NORTHEAST UTILITIES

Docket No. 50-423
B11162

Millstone Nuclear Power Station, Unit No. 3
Responses to Containment Systems Branch Questions 480.19 and 480.34

FIGURE 6.2-57
 EXPECTED LONG-TERM CIRCULATION
 PATTERNS IN CONTAINMENT
 MILLSTONE NUCLEAR POWER STATION
 UNIT 3
 FINAL SAFETY ANALYSIS REPORT

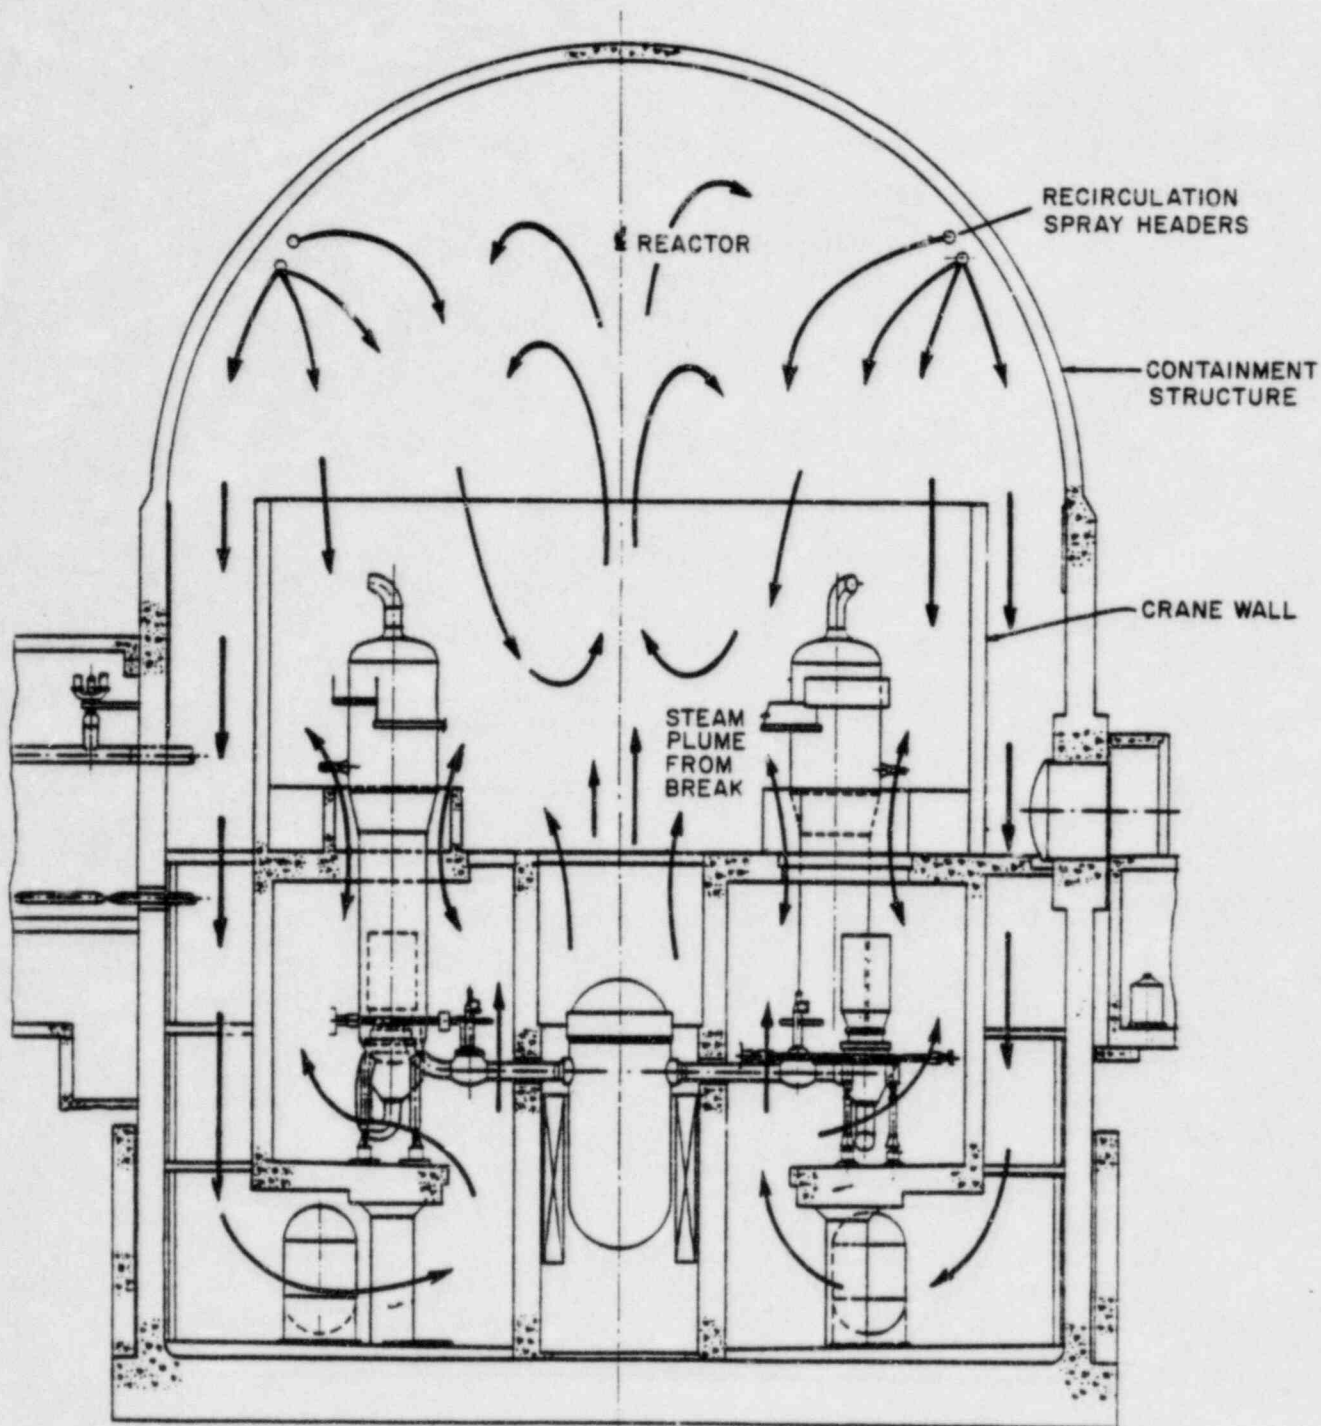
Discuss the effectiveness of convection mixing and/or recirculation spray operation to mix combustible gases that may be generated within the containment following onset of a postulated LOCA. Describe the design features of the containment which promote mixing of the atmosphere, and identify the compartments which may not achieve effective mixing of combustible gases. Provide sketches to show the expected circulation patterns within the containment compartments.

Figure 6.2-57 depicts the expected predominant circulation patterns within the containment after termination of the initial release from LOCA.

The majority of gas mixing results from the spray systems. The recirculation spray entrains air, and its predominantly downward motion forces the gas mixture to the lower elevations and, in turn, up through and between the various compartments.

Steam pluming is a secondary mixing effect which assists in the overall gas mixing process. The steam plume from the break is vertically upward from either the steam generator, pressurizer, or upper reactor cavity subcompartment depending on the break location. This effect generally enhances the mixing process in the region above the operating floor and within the compartment where the break occurs.
